**RE :** Corrib gas IPPC licence application no. PO738-02 by Shell E&P Ireland Ltd.

**Report to Erris Inshore Fishermens Association on  
IPPC Application P0738-02 by Shell E&P Ireland Limited**

**Issued by:  
Leo Corcoran CEng., MBA, FIEI.  
Energy & Environmental Consultant  
16th June 2010**

**Fig. F.1 Umbilical Cores**

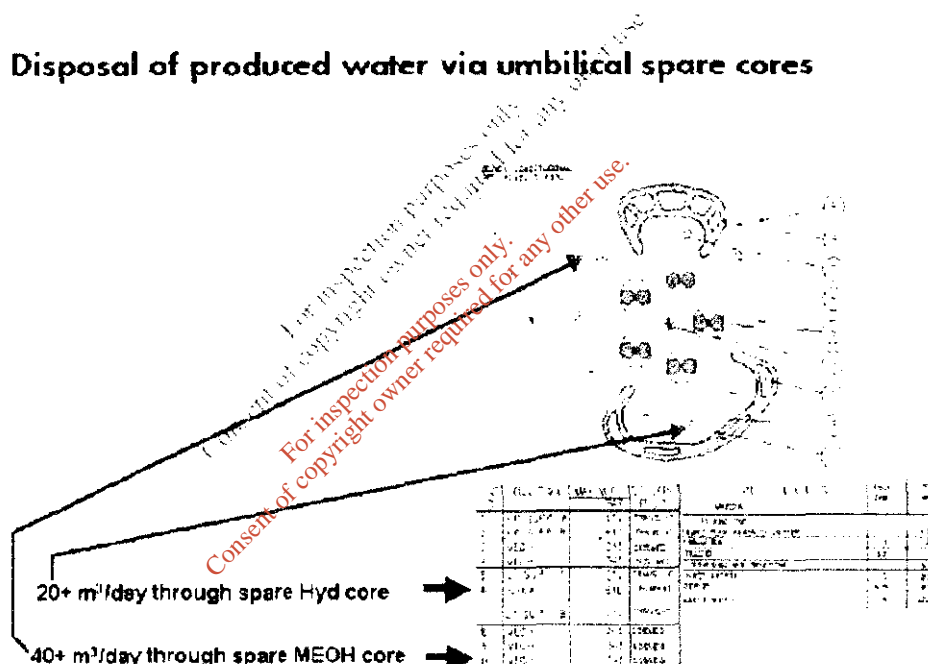
The Application proposes discharging up to 80 m<sup>3</sup>/day of Produced Water. This will be achieved by utilising spare cores in the umbilical, Spare Core number 6 will have a capacity of up to 20 m<sup>3</sup>/day and Spare Core 10 will have a capacity of 40 m<sup>3</sup>/day, with the remainder 20m<sup>3</sup>/day being removed by road tanker. Due to the decline of Produced Water during the life of the field it is estimated by SEPIL that the removal of PW by road tanker will not be required after year 4 and that only one core will be required to discharge PW after year 6.

### Produced Water Shipped via Road Tanker

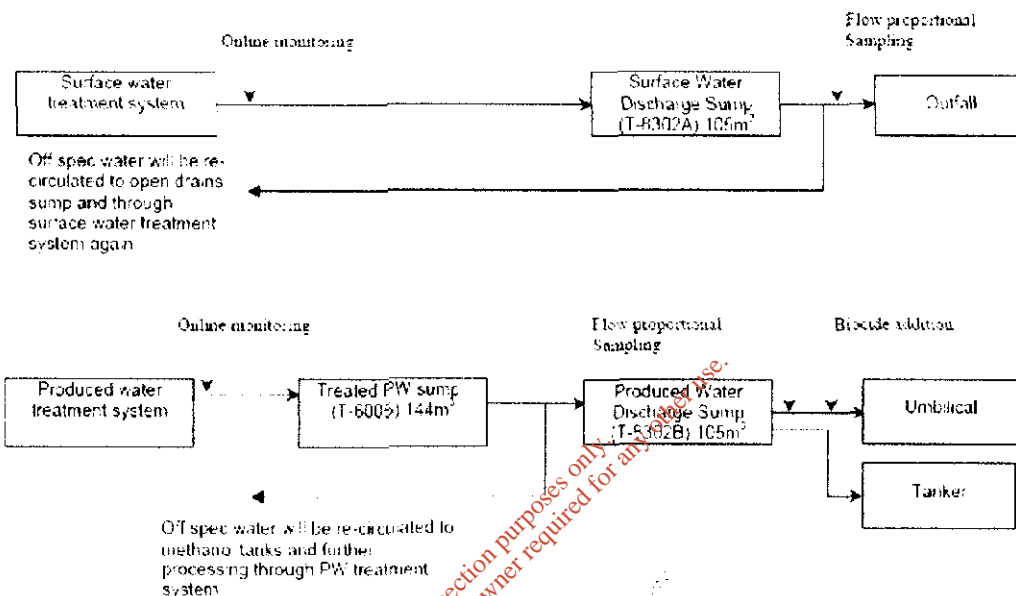
No details are provided in the application on the discharge location of Produced Water shipped via road tankers. There should be full transparency on the final transportation treatment and discharge of PW shipped via tankers.

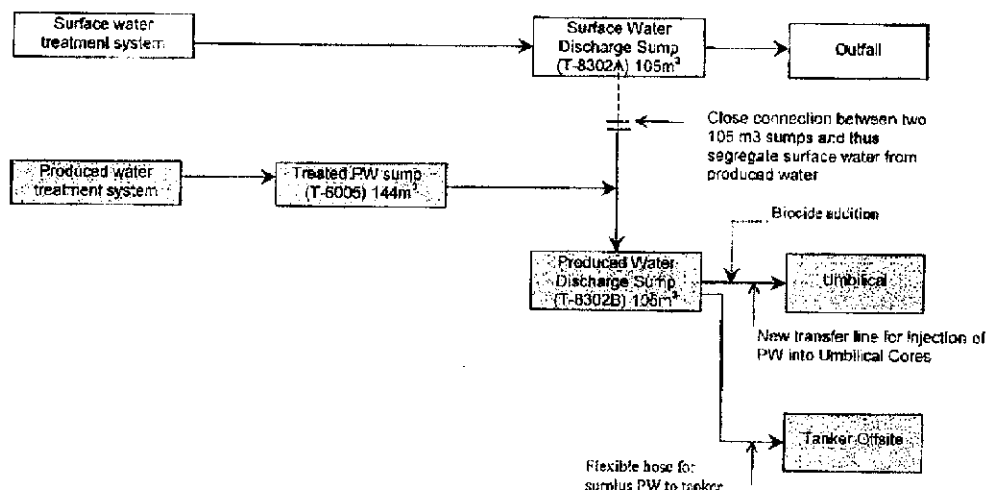
The current application indicates that there is complete separation between the two systems. The initial application to the EPA indicated that there is a closed connection between the two systems.

It was not possible to view the connection between the Surface Water Discharge Sump and the Produced Water Discharge Sump as this would require entry into a confined space. SEPIL provided a diagram of the interconnection indicating a valve with a blind flange at one end and spool piece terminating in a blind flange. SEPIL stated that the two systems had been completely separated by welding a spade internally on the spool piece. Additionally the hand wheel of the valve has been removed. It was further stated that it was not possible to remove the valve as it had been partially encased in the concrete structure of the of the sump wall.

It is unusual to encase a valve in concrete by design. It is unclear if this was an oversight during construction or if there was some other reason for constructing the connection between the two sumps in this manner.

Offshore Field Facilities layout Source: Corrib Offshore EIS

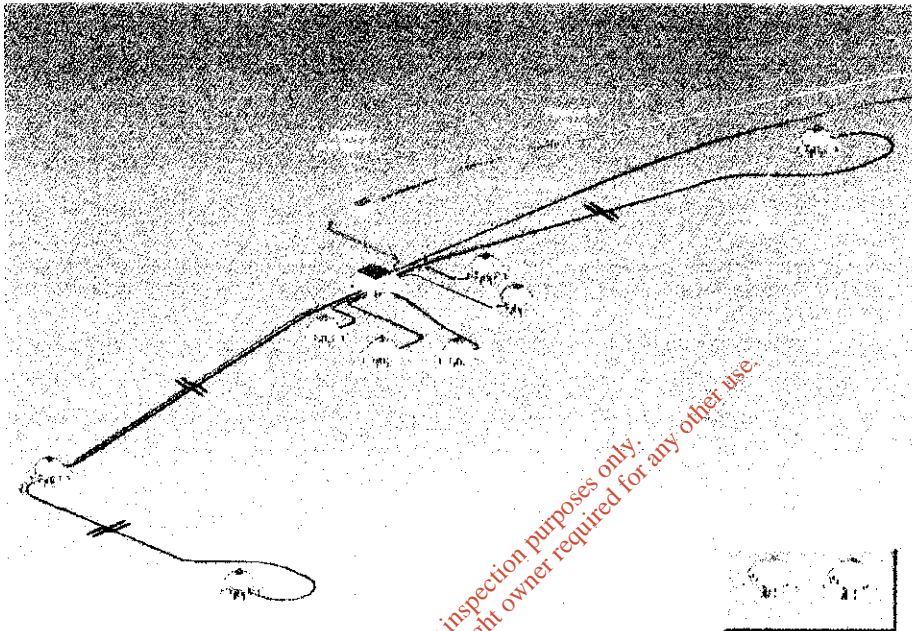
Since these cores are now allocated to the discharge of Produced Water some risk will be transferred from the environmental risks of discharging PW to Broadhaven Bay to the integrity and security of the umbilical, the subsea modules and the wellhead valves. A Risk Assessment will be required to determine these risks and to assess if they are acceptable. These risks fall into two categories;

The safety of the subsea system will be evaluated in a Safety Case to be submitted by SEPIL to the Commission of Energy Regulation (CER) under section 13 of the Petroleum (Exploration and Extraction) Safety Act 2010 (PEESA). This Act will require SEPIL to hold a Safety Permit before production commences. During the review of this IPPC licence application the EPA should refer the use of spare cores for the purpose of which they were not originally designed to the CER. While the EPA will consider the use of these cores from an environmental perspective the CER will evaluate their use by considering the Safety Case to be submitted by SEPIL and by determining if the revised design is acceptable from a safety perspective. Considering that the subsea infrastructure will be installed at a dept of 350m beyond the safe limit of divers any future physical modifications or alterations would have to be carried out using Remotely Operated Vehicles (ROVs). SEPIL have stated in their submission to the EPA that the cores are

entirely reversible should "the cores be required for chemical or hydrate duty". No details are provided on what processes and procedures would be deployed in such a scenario and in particular how the SEPIL/EIFA agreement would be maintained in the event that the cores were reversed. It should be demonstrated by SEPIL in their Safety Case that the revised design does not compromise the integrity and safety of the subsea infrastructure.

Figure F.1.5.1: Schematic of the Biocide Dosing of the Treated Produced Water Discharge System.

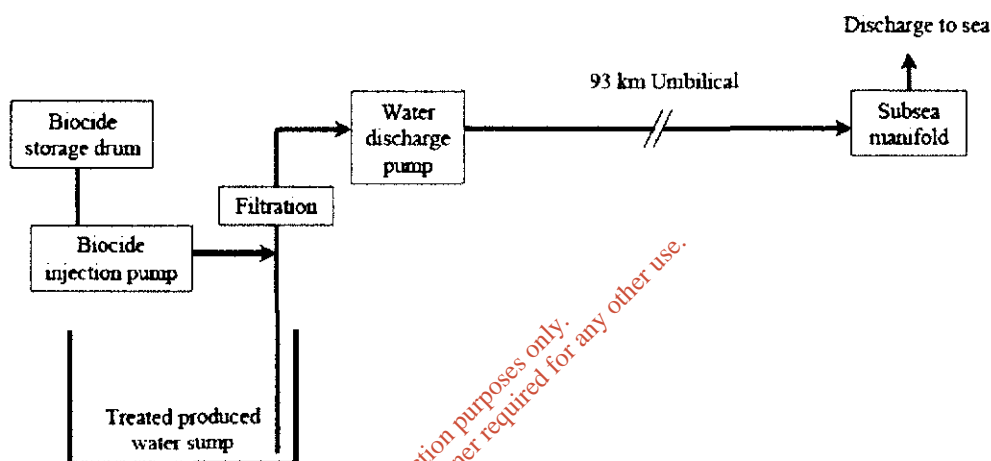
An analysis of the treated produced water discharge system has shown that a change of core surface roughness or reduction of internal diameter, due to biological growth will significantly reduce the discharge capacity of the system. Biological growth can also induce pitting corrosion which can rapidly penetrate pipe walls. SEPIL proposes treating produce water by dosing with biocide compound DBNPA.

SEPIL have estimated that DBNPA will degrade at the discharge point and will not bio accumulate in the marine environment.
